ELECTRONICS FIELD CHANGE BULLETIN
 U. S. NAVAL SHORE ELECTRONICS ENGINEERING
 3431 CARLYN SPRING ROAD
 BAILEY'S CROSSROADS, VIRGINIA

MODIFIES 0-941/UR
 CIRCUITS TO PROVIDE AUTOMATIC
 CONNECTION OF 0- 941/UR
 AS FREQUENCY STANDARD FOR
 ASSOCIATED EQUIPMENT WHEN
 EXTERNAL STANDARD FAILS

EQUIPMENT AFFECTED: 0-941/UR (Commercial Designation: HFS-1)

TEMPORARY CORRECTION TO TECHNICAL MANUAL
IN-3001B FOR CONTROL SYNTHESIZER AND STAN-
DARD MODEL HFS-1 (Military Designation:
0-941/UR)

Figure 1. Rear Panel of HFS.

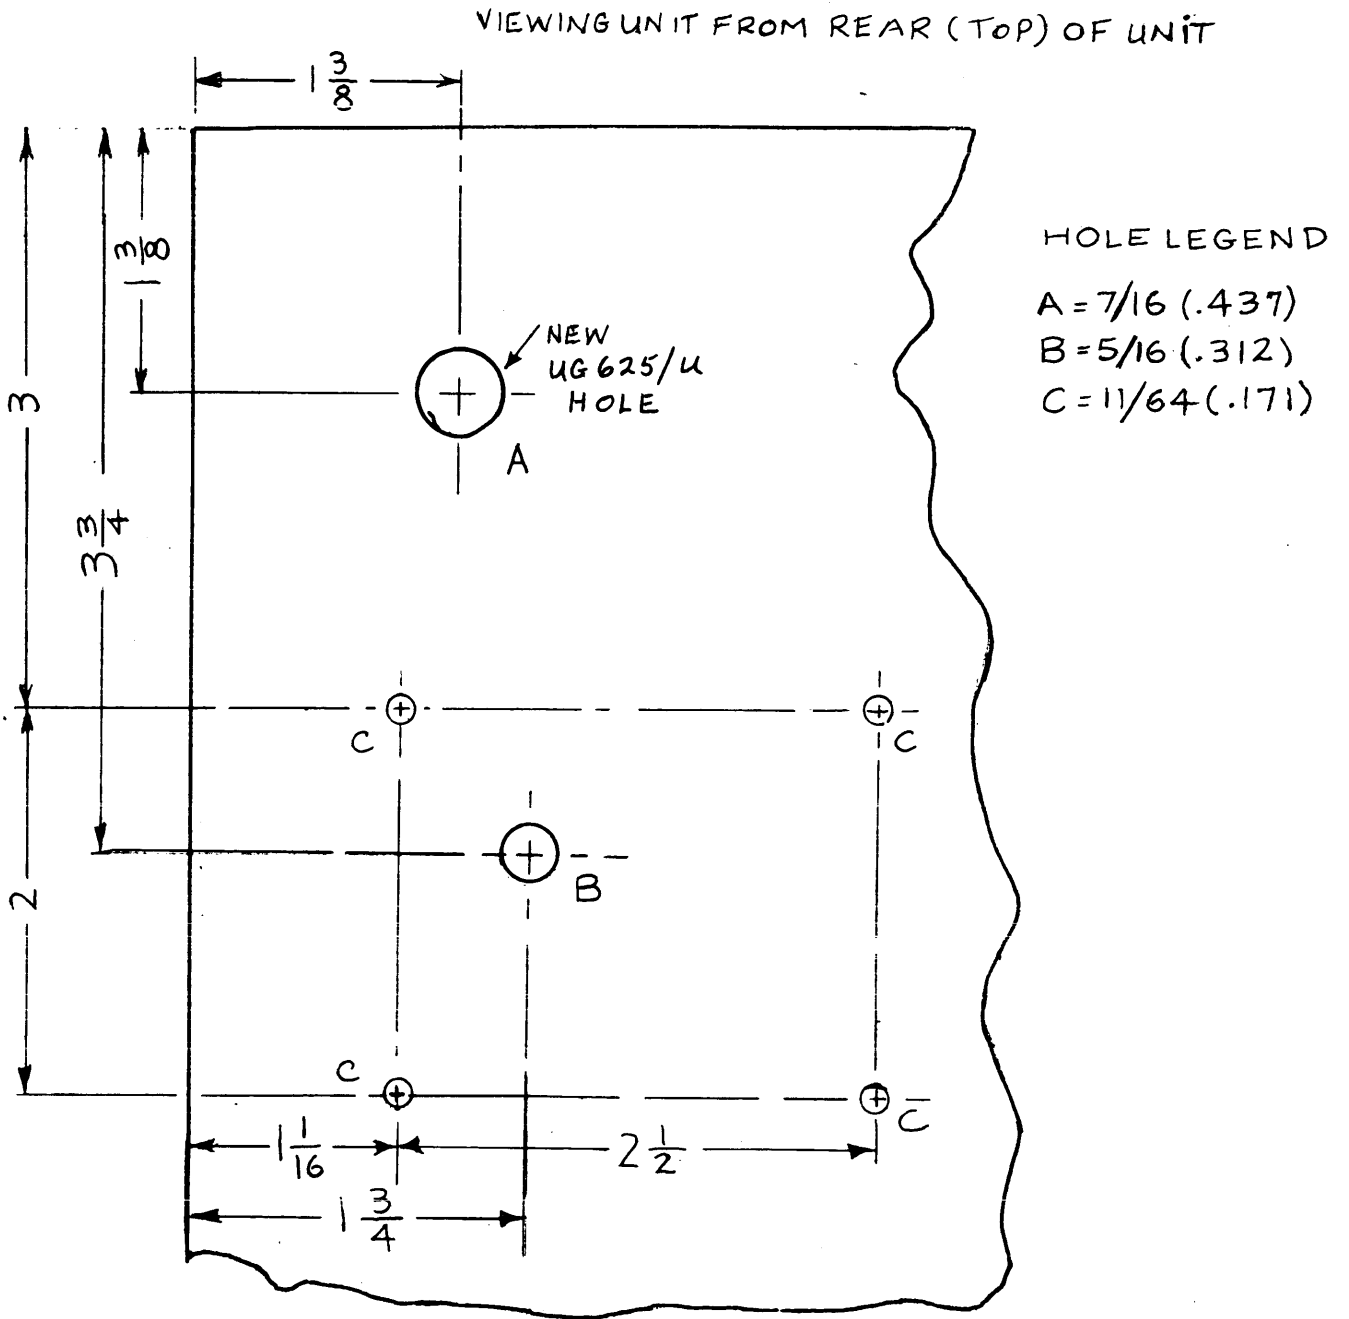
14. Use 11/64-inch drill bit (item 11, table 1) and electric drill (item 6, table 2) to drill four 11/64-inch holes in HFS chassis as shown in figure 1.

15. Use 5/16-inch drill bit (item 10, table 1) and electric drill 5/16-inch hole in HFS chassis as shown in figure 1.
16. Press grommet (item 3, table 1) into hole drilled in step 15.

Figure 2. Modification, Cabling Diagram

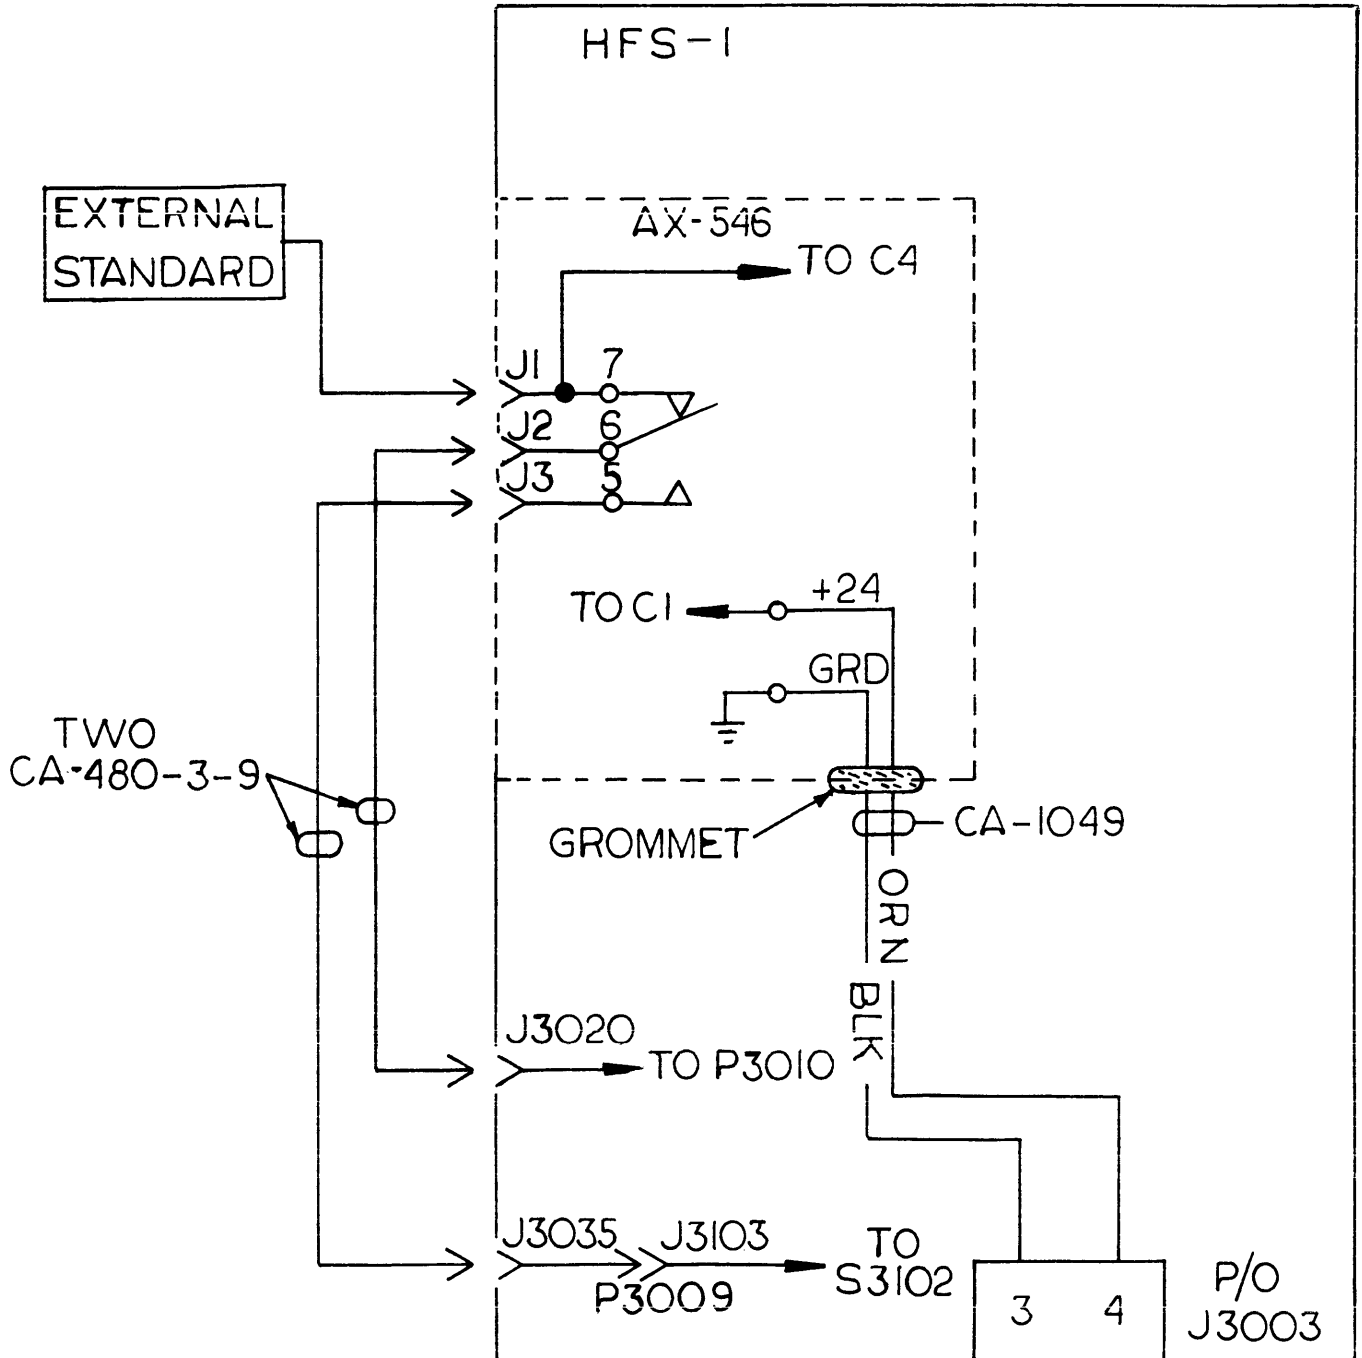
17. Solder one end of cable CA-1049 (item 8, table 1) to relay switch assembly AX-546 (item 1, table 1), see figure 2 , as follows:
 - (a) Orange wire to 24-volt terminal of AX-546.

20. Pass free end of CA-1049 through grommet located below jack J3001; route CA-1049 under chassis to jack J3003.
21. Solder free end of CA-1049 to jack J3003, see figure 2, as follows:

- (a) Orange wire to pin 4 of J3003.
 - (b) Black wire to pin 3 of J3003.
22. Clean all metal drilling parts from HFS.
23. Plug capacitor C3001 (removed in step 5) into its socket.

HFS-1, Interconnection Diagram

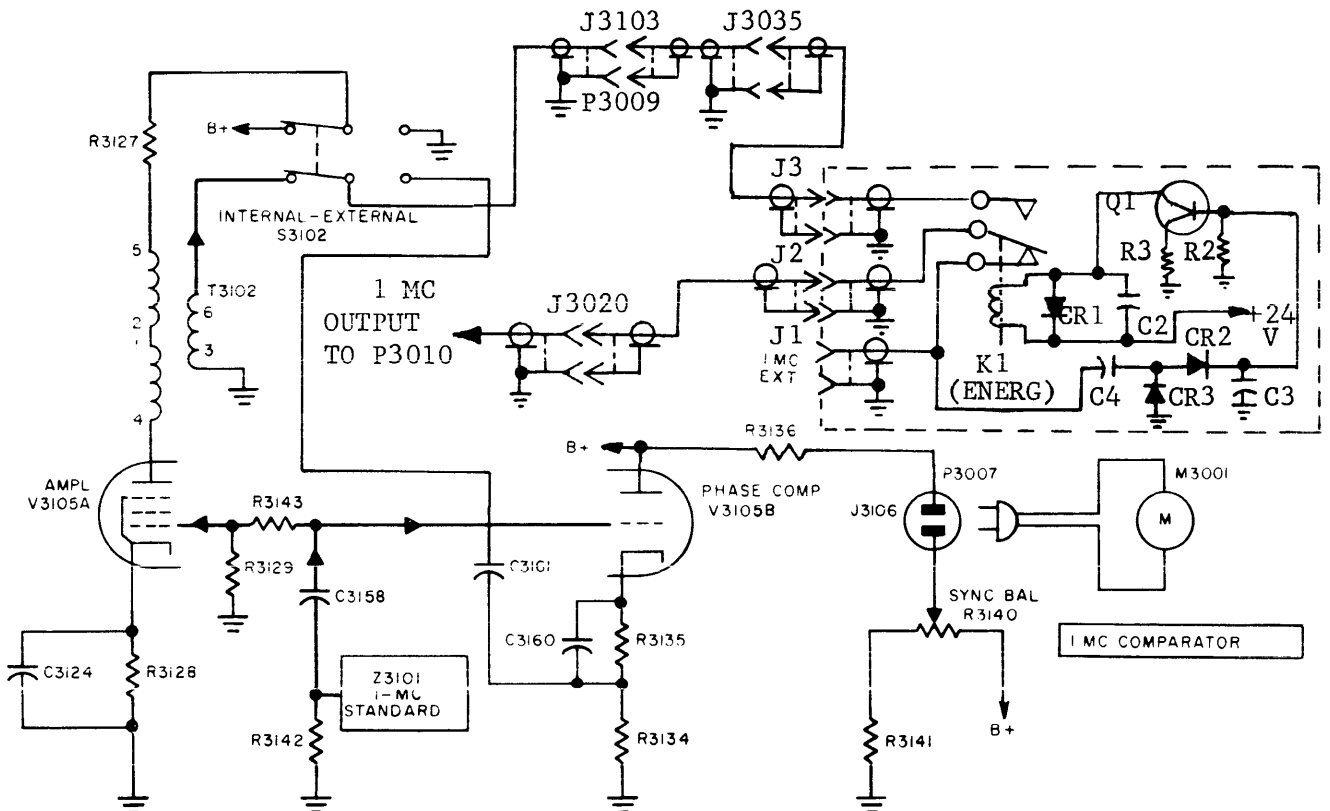
7. Paste HFS-1 Interconnection Diagram, supplied with this temporary correction, over figure 2-2, page 2-2 in HFS-1 manual.
8. In paragraph 3-3, page 3-2, change second sentence to read:
"However, should you want to use an external 1-mc signal, make connection as shown in figure 2-2 and keep the INT/EXT switch S3102 in the INT position,"

Revision of sheet 1 of figure 8-1.

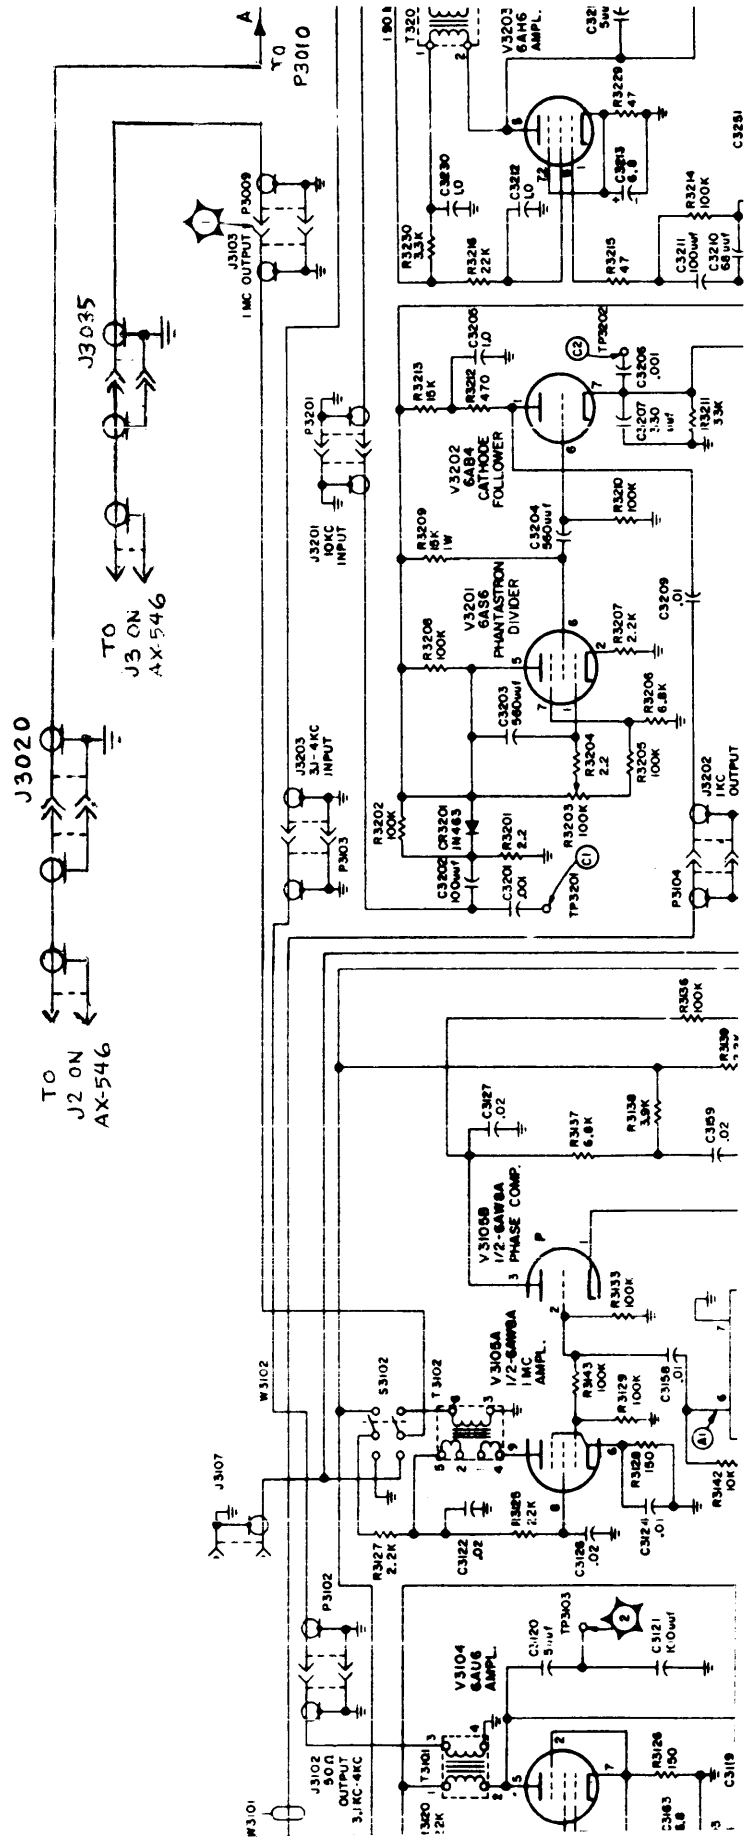
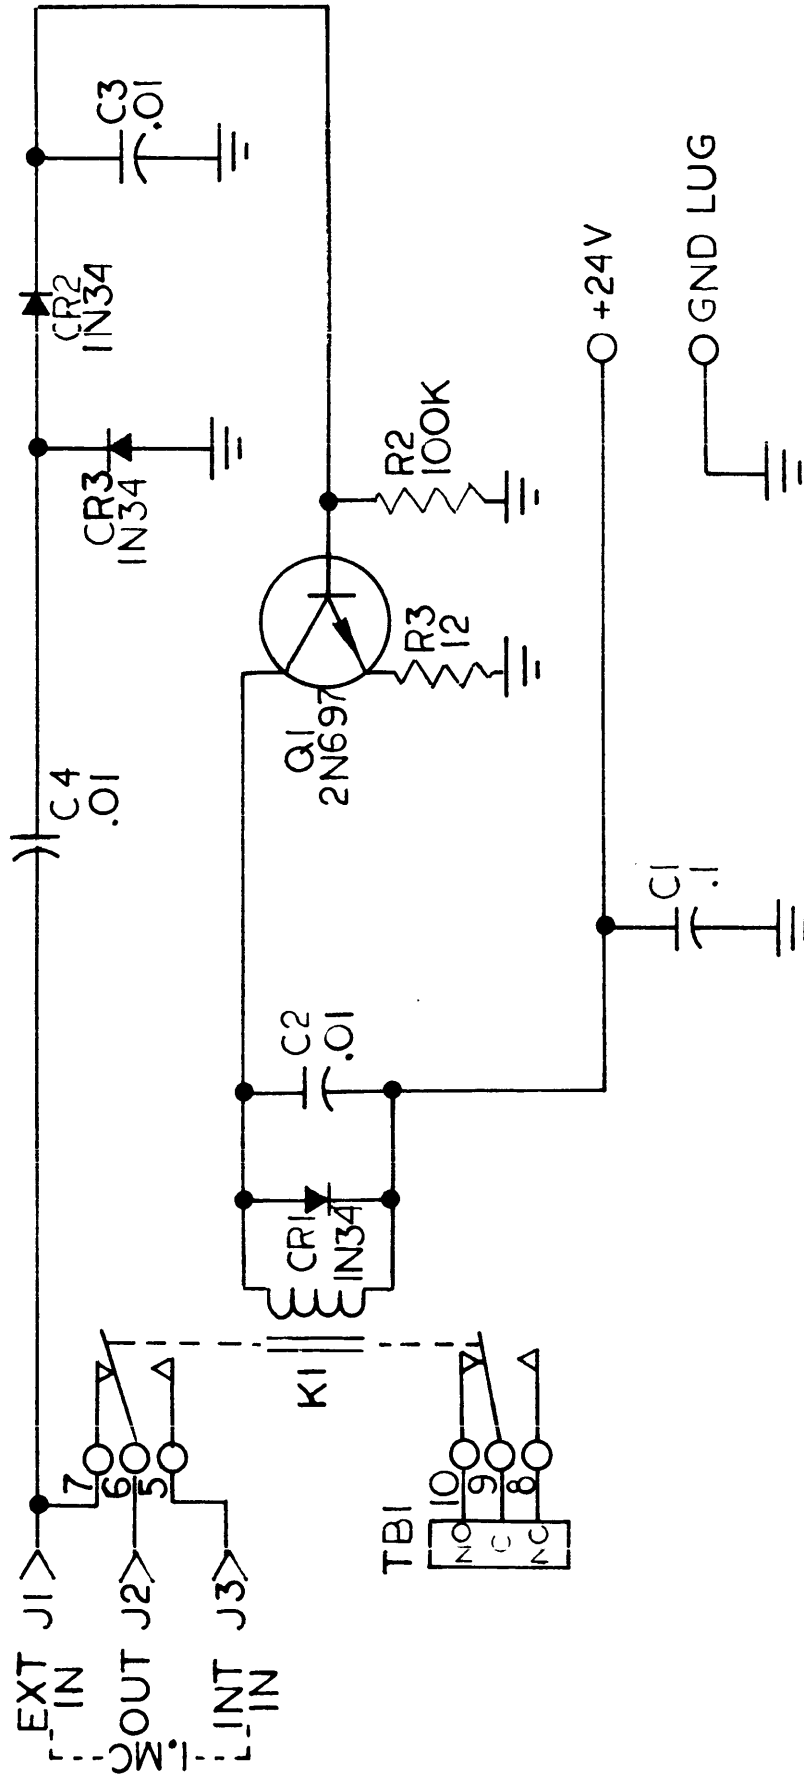
14. Make a copy of figure 8-1 (Sheet 1 of 3), page 8-3/8-4, in HFS-1 manual. Retain this copy in support of equipments that have not been modified.
15. Paste circuit revision of sheet 1 of figure 8-1, supplied with this temporary correction, over 1-mc input area (as indicated by reference components in the revision) onto figure 8-1, sheet 1 in HFS-1 manual.
16. Insert AX-546 Switchover Assembly Schematic Diagram, supplied with this temporary correction, between sheet 3 of figure 8-1 (page 8-7/8-8) and back cover in HFS-1 manual.
